## Suspension - Front Suspension Popping Noises

TSB 07-18-1

FRONT [SUSPENSION](#) POPPING NOISE WHILE  
TURNING RIGHT OR LEFT - VEHICLES BUILT  
BEFORE 4/8/2005

FORD:  
2005 Mustang

Figure 1

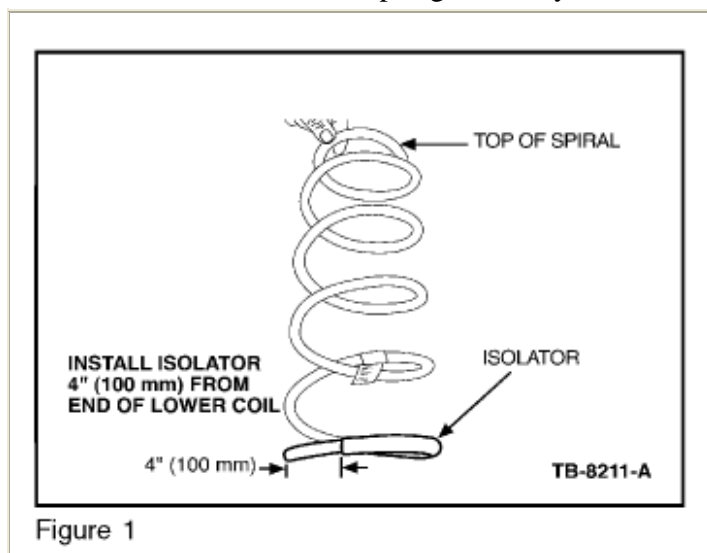
3. If the springs do not have a rubber isolator on the bottom spring coil, install isolators. Clean off any dirt prior to installing the isolator. The isolator should be installed 4" (100 mm) from the end of the coil (Figure 1).
